ARCHITECTURAL REVIEW BOARD MEETING
CITY HALL, 385 SOUTH GOLIAD STREET, ROCKWALL, TEXAS
JULY 28, 2026 IN THE CITY COUNCIL CONFERENCE ROOM AT 5:00 PM

PROJECT COMMENTS

PROJECT NUMBER: SP2026-014
PROJECT NAME: Site Plan for 5133 S FM 549
SITE ADDRESS/LOCATIONS: 5133 South Farm to Market 549, Rockwall, TX, 75032

PLANNING AND ZONING COMMISSION MEMORANDUM

TEXAS SOCIAL DRIVING
RANGE & PARKING-PHASE-1
S.H. 205
ROCKWALL, TX 75032
LANDSCAPE PLAN

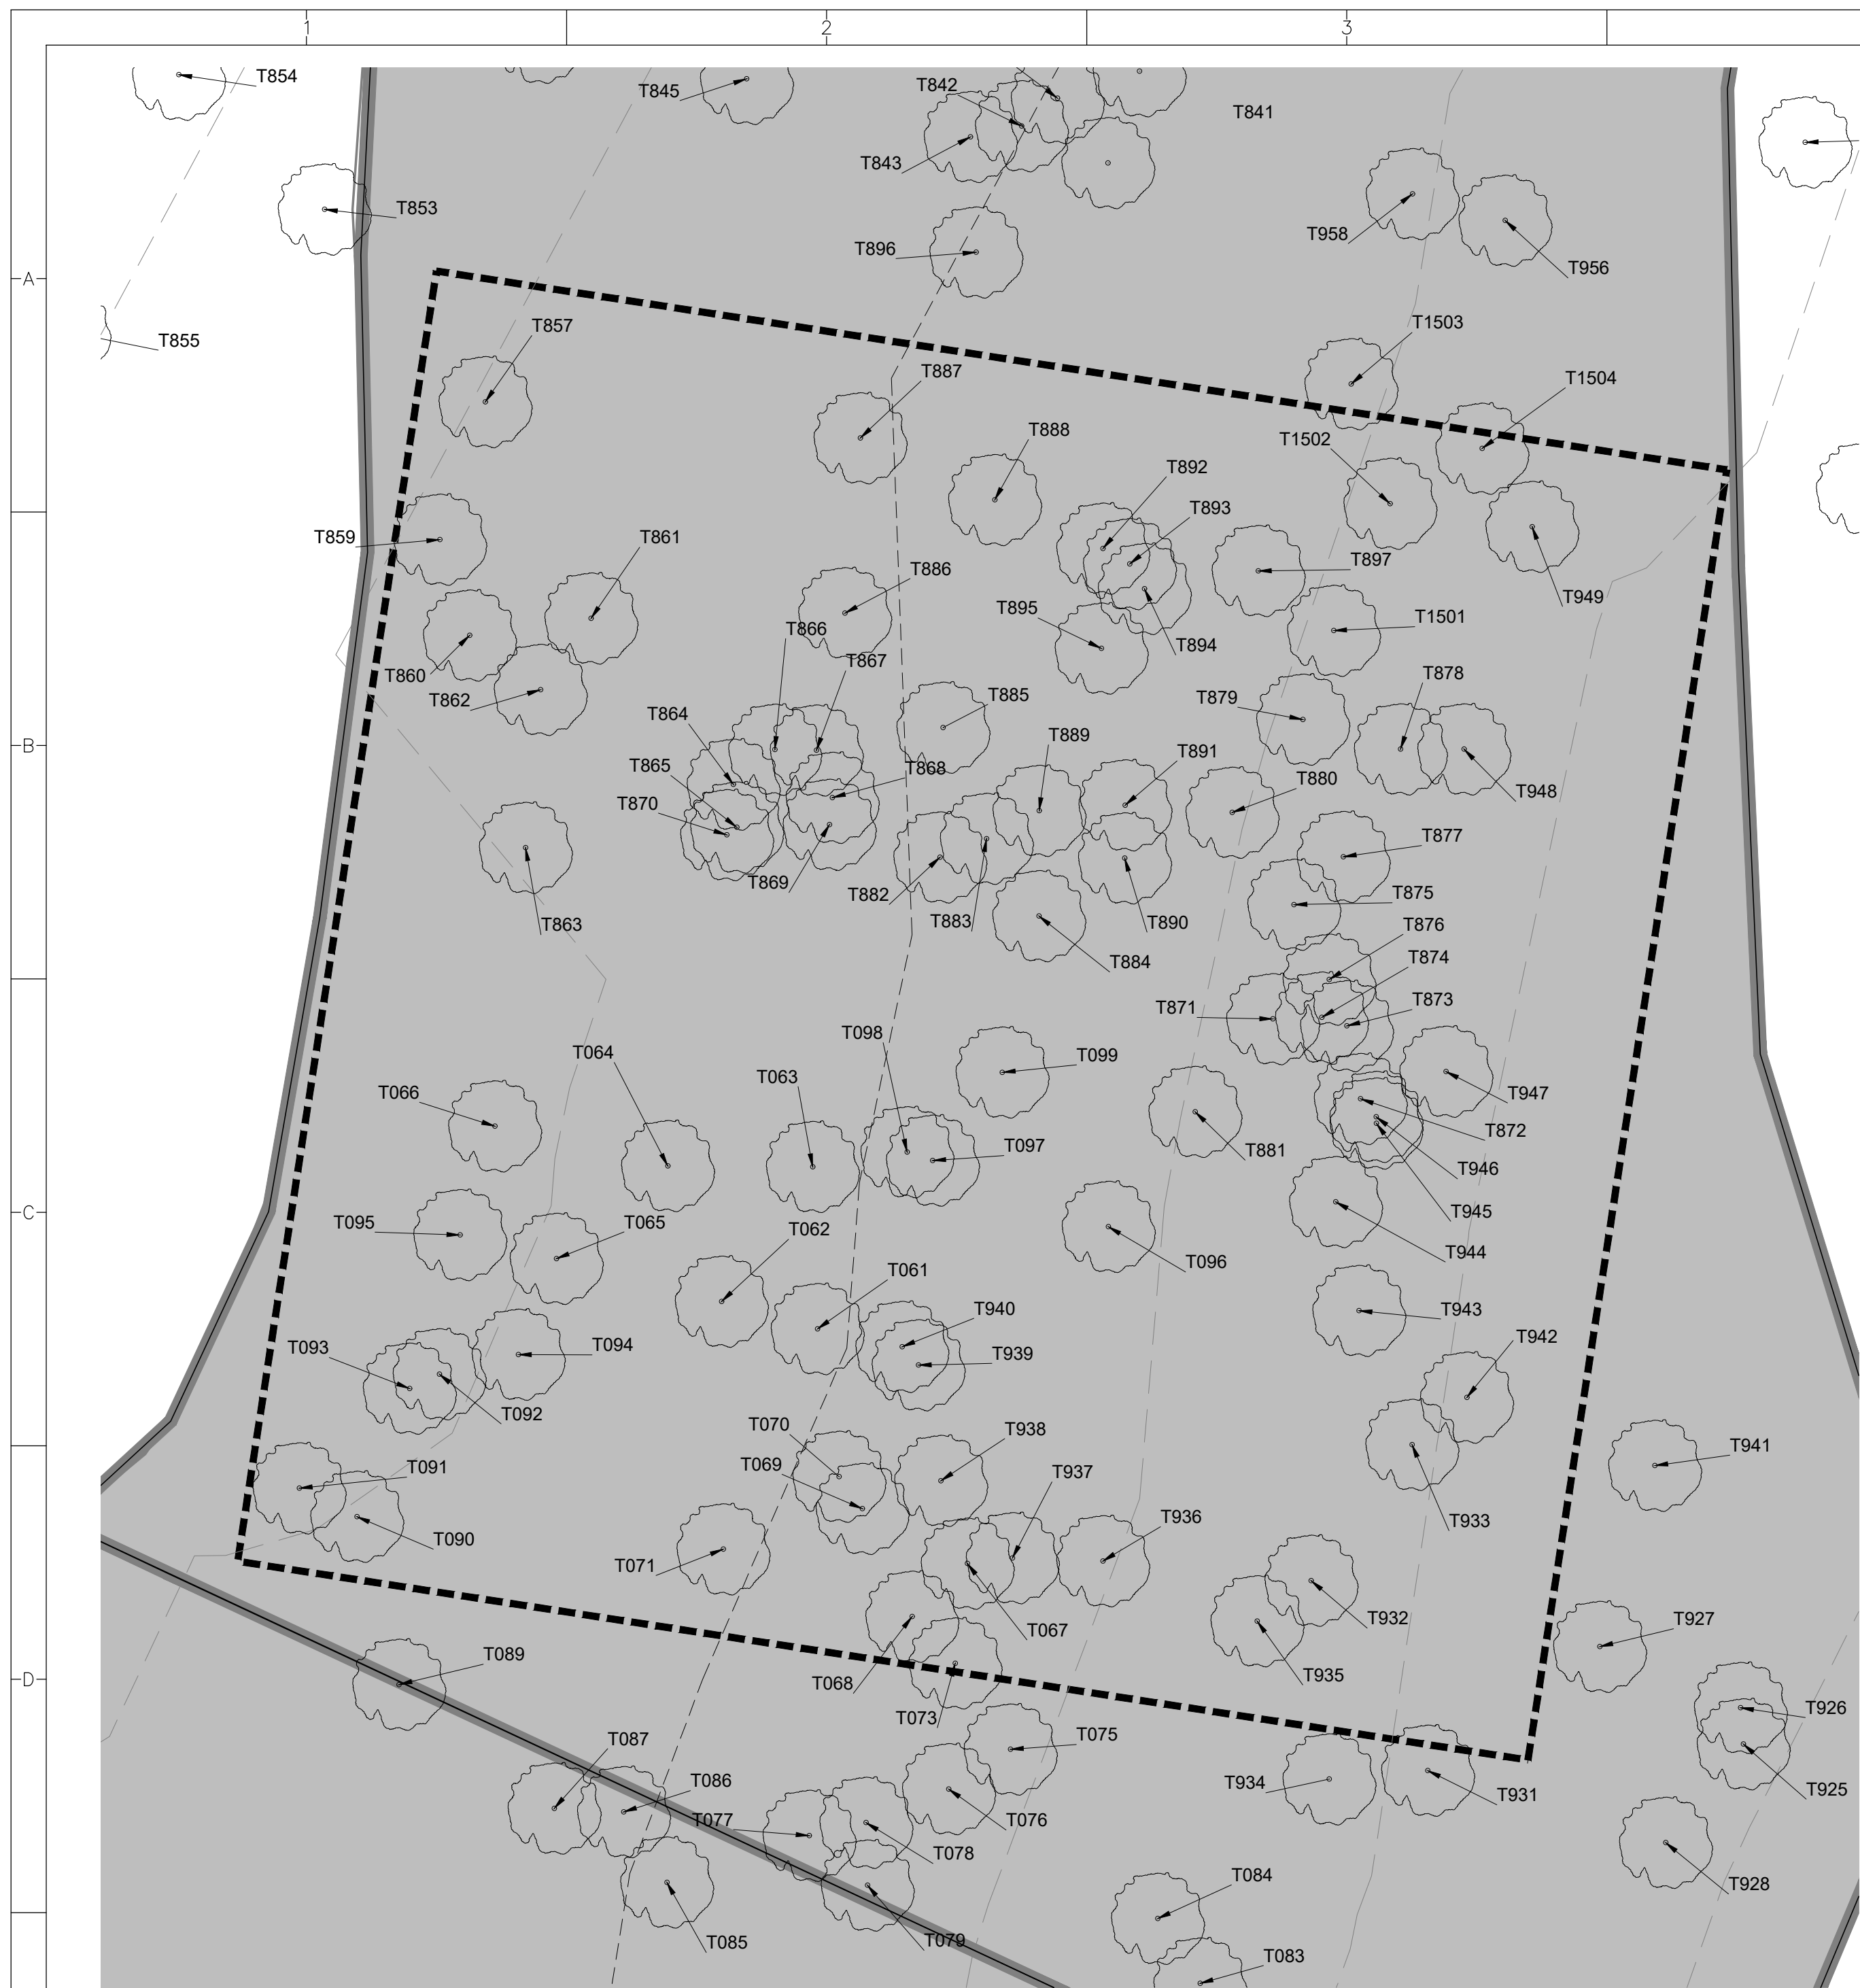
- (1) Please remove the improvements and buildings associated with Phase 2. This area can be labeled as Phase 2, but we cannot have any improvement shown in this area. (Subsection 03.04. B, of Article 11, UDC)

- (3) Please provide the impervious vs. landscaped area. Indicate the applicable zoning district percentage of landscaping required and provided, and the impervious area vs. the amount of landscaping and open spaces required and provided. (Subsection 01.01. B, of Article 08, UDC)

- (4) Please provide a landscape table showing plant materials, quantities, size and spacing for existing and proposed landscaping. Complete description of plant materials shown on the plan, including names, locations, container or caliper sizes at installation. Canopy trees must be four (4) inch caliper, accent trees must be four (4) feet in height, and all shrubs must be five (5) gallons. (Subsection 05.03. B, of Article 08, UDC)

- (7) Given that the parking and maneuvering area exceeds 20,000 SF there must be one (1) large canopy tree for every ten (10) parking spaces planted internal to the parking areas. (Subsection 05.03. (E)(2), of Article 08, UDC)

- (8) Please provide note indicating irrigation will meet requirements of UDC. (Subsection 05.04, of Article 08, UDC)
- (9) Artificial or synthetic plant materials (e.g. artificial grass, turf, trees, and/or shrubs) shall be prohibited on all non-residentially zoned or used property in the City of Rockwall; however, the Planning and Zoning Commission can grant an exception where it is found that the artificial plant materials are integral to the operations of the proposed non-residential land use or where it will serve as an on-site amenity to the nonresidential land use. Please detail where any artificial turf will be utilized and its purpose. (Section 04. (B), of Article 08, UDC)

TREESCAPE PLAN

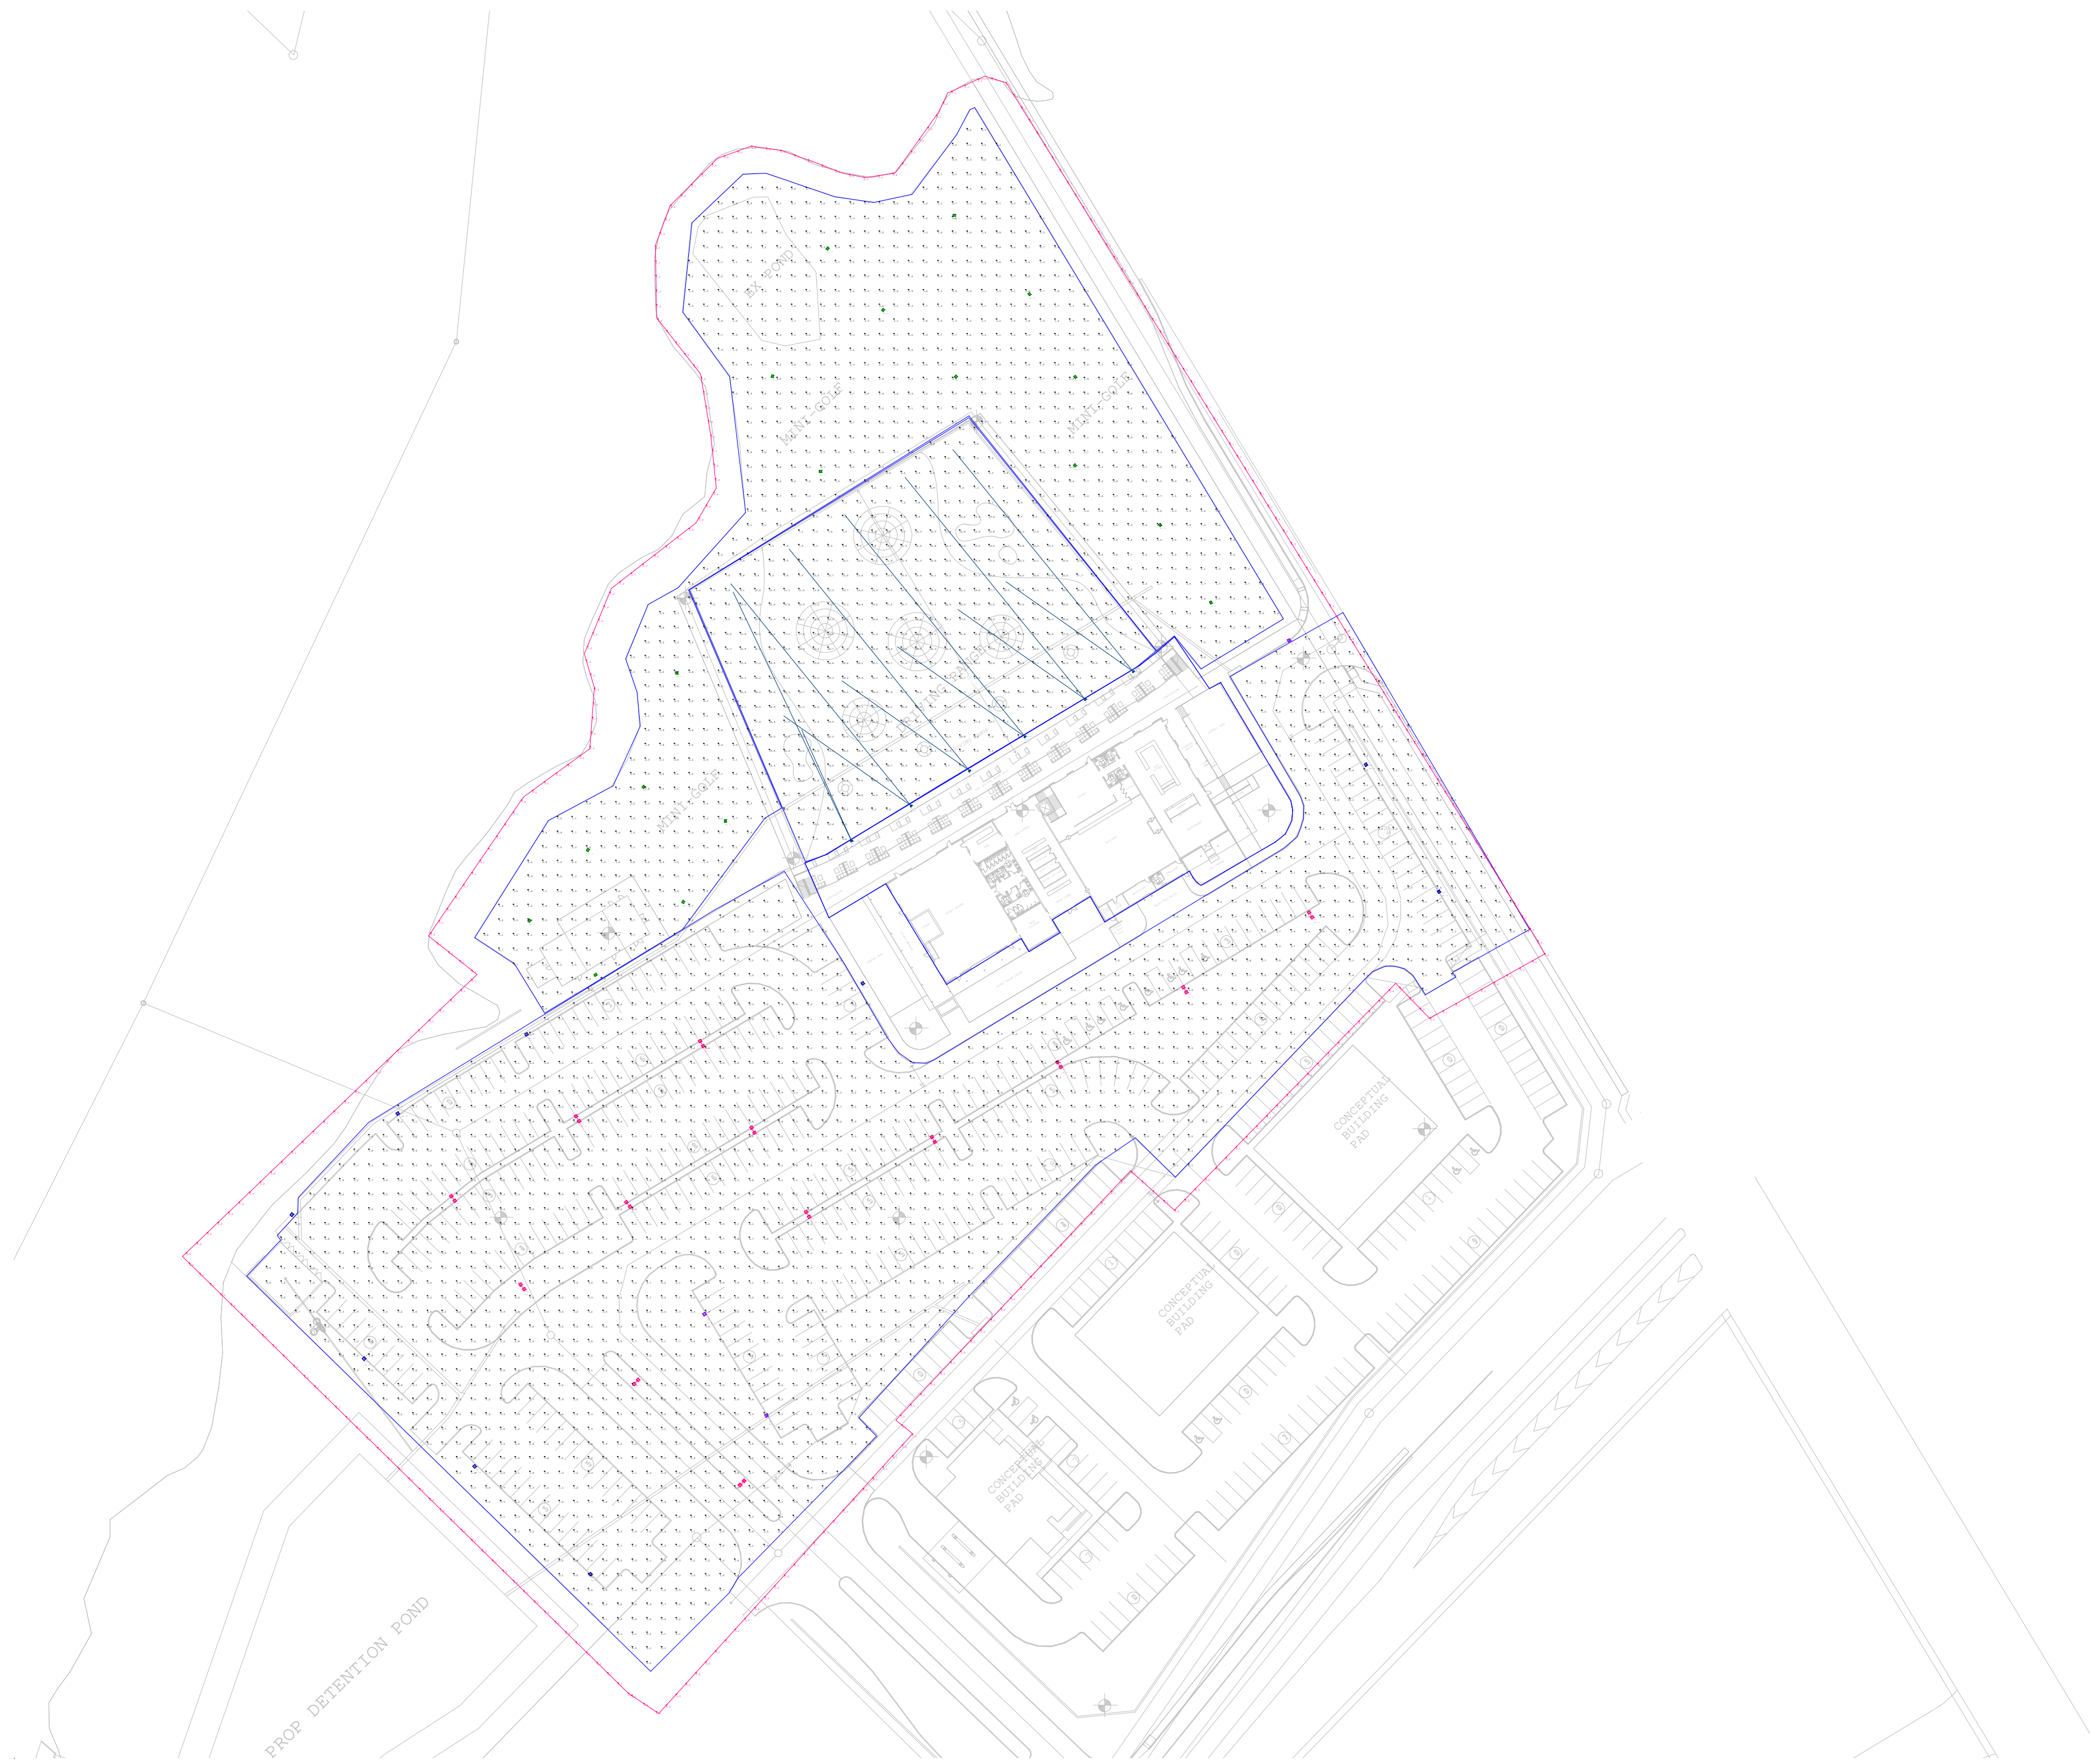
- (1) Provide the same site data information required in Section 2.1 Site Plan: Miscellaneous and Density and Dimensional Requirements of this checklist. (See Sec. 2.1 of the checklist)
- (2) Please indicate the location of all existing or proposed structures or buildings. (Subsection 03.01. (A), of Article 08, UDC)

(3) Based on the provided treescape plan, you will be required to request an Alternative Tree Mitigation Settlement Agreement. This agreement will require the approval of both the Planning and Zoning Commission and the City Council. In this case, you are requesting to not require mitigation for Eastern Red Cedar trees and to utilize sample areas for the tree mitigation.
